<b>Title - Sujet</b> Remplacement de l'ASI du CNRC au We Remplacement de l'ASI du CNRC au West Saanich	
<b>Solicitation No. - N° de l'invitation</b> EZ899-221150/B	<b>Amendment No. - N° modif.</b> 003
<b>Client Reference No. - N° de référence du client</b>	<b>Date</b> 2021-11-08
<b>GETS Reference No. - N° de référence de SEAG</b> PW-SPWY-047-9067	
<b>File No. - N° de dossier</b> PWY-1-44107 (047)	<b>CCC No./N° CCC - FMS No./N° VME</b>
<b>Solicitation Closes - L'invitation prend fin</b> <b>at - à 02:00 PM</b> Pacific Standard Time PST <b>on - le 2021-11-16</b> Heure Normale du Pacifique HNP	
<b>F.O.B. - F.A.B.</b> <b>Plant-Usine:</b> <input type="checkbox"/> <b>Destination:</b> <input checked="" type="checkbox"/> <b>Other-Autre:</b> <input type="checkbox"/>	
<b>Address Enquiries to: - Adresser toutes questions à:</b> Kyle (PWY), Davis	<b>Buyer Id - Id de l'acheteur</b> pwy047
<b>Telephone No. - N° de téléphone</b> (250) 869-6395 ( )	<b>FAX No. - N° de FAX</b> ( ) -

Solicitation Amendment 003 is raised to indicate that:

1. Answer questions in attached addendum 3.

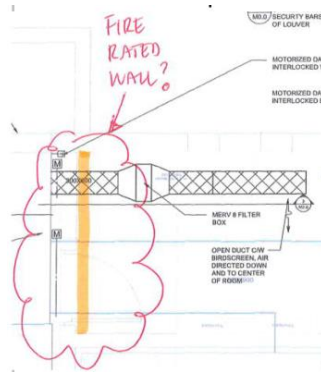
**Q.3** In order to provide the correct steel quantities for the security bars, what are the existing louvre sizes?

**R.3** *Louvers are 52" x 52".*

#### UPS-1

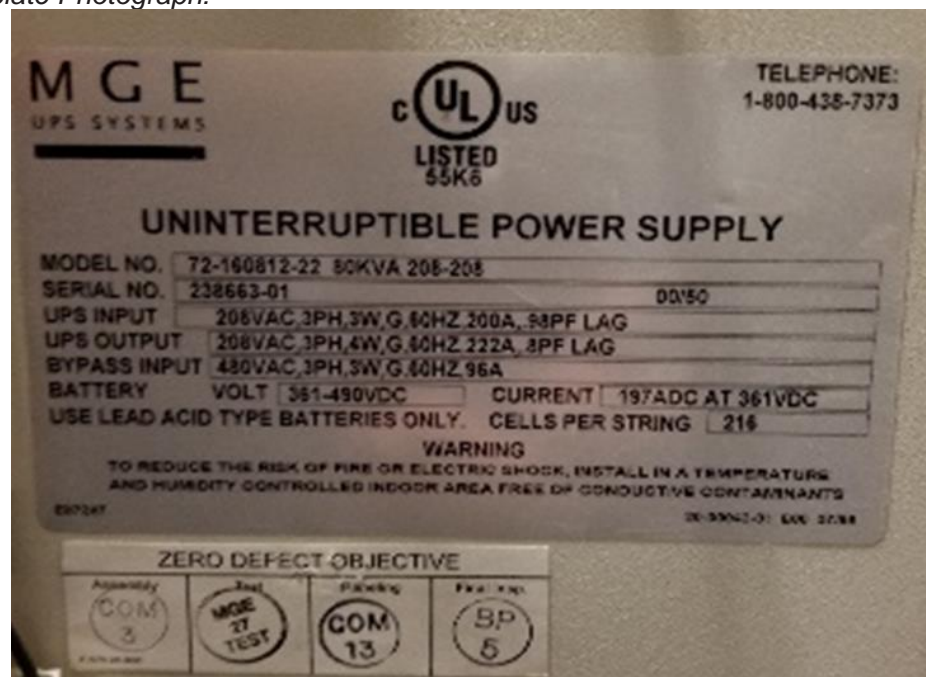
**Q.7** Can we get pictures of the nameplates on the current UPS 1 & 2 showing Manufacturer and model Number

**R.7** Photo Provided, both UPS units are the same model: Comet 80 kVA UPS, EOSL, OEM = Schneider Electric.
